STAFF RECOMMENDATION 1115 Lillian Street July 15, 2015

Application: Demolition, New construction-infill
District: Lockeland Springs-East End Neighborhood Conservation Zoning Overlay
Council District: 06
Map and Parcel Number: 08313012400
Applicant: John Root, Architect
Project Lead: Melissa Baldock, melissa.baldock@nashville.gov

Description of Project: The applicant is proposing to demolish a non-contributing structure and to construct a new one and one-half story house with attached parking.

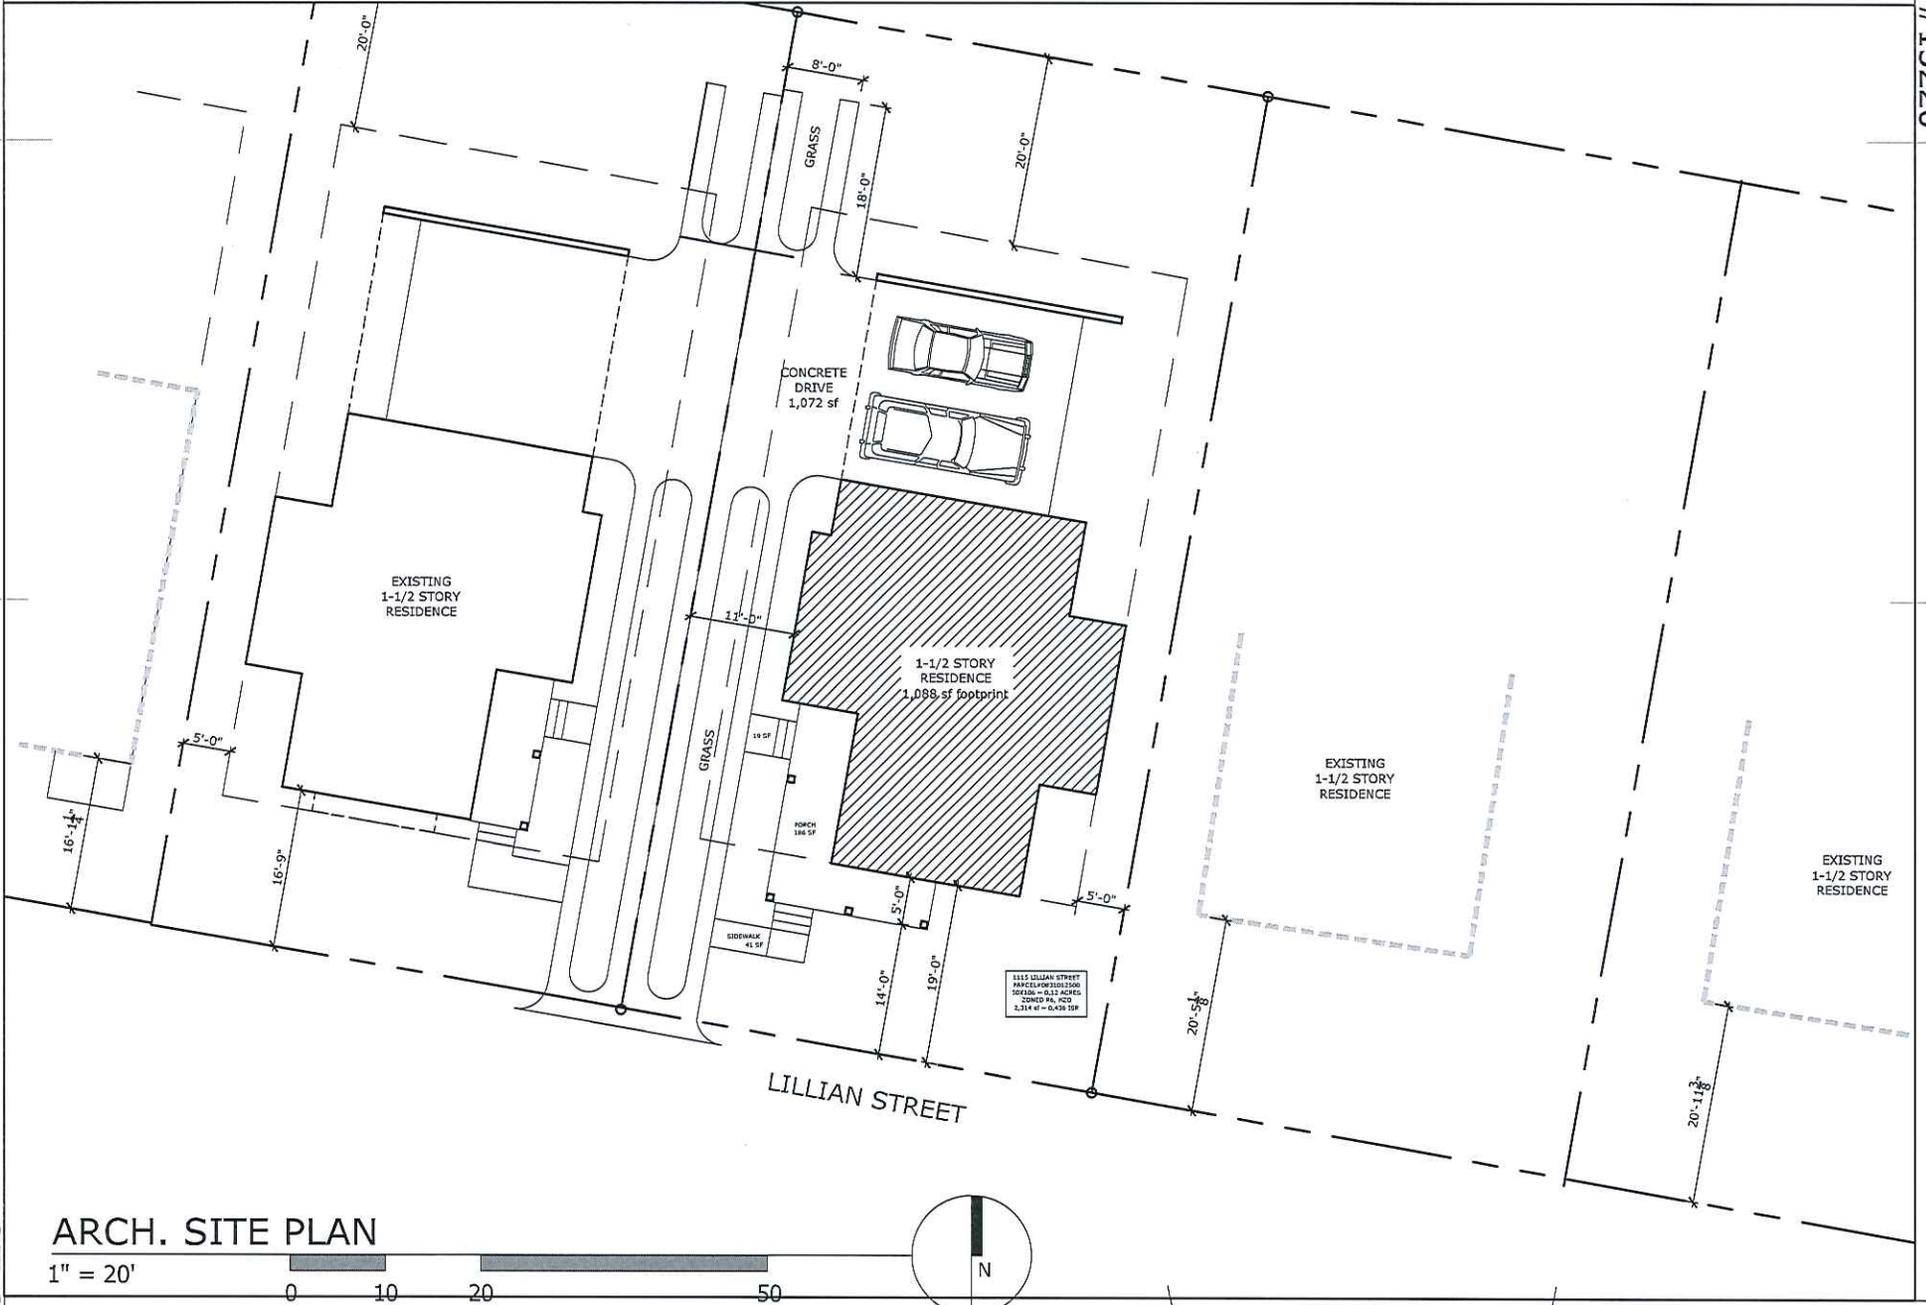
Background: 1115 Lillian Street was constructed c. 1955, and it does not contribute to the historic character of the Lockeland Springs-East End Neighborhood Conservation Zoning Overlay (Figures 1 & 2).

Demolition: The style, form, and detailing of the existing building do not match the historic context of neighborhood. Its low slope roof, shallow eaves, fenestration pattern, and details are inconsistent with the predominant historic character of Lockeland Springs. In addition, the building is not a good example of its period of development. Staff
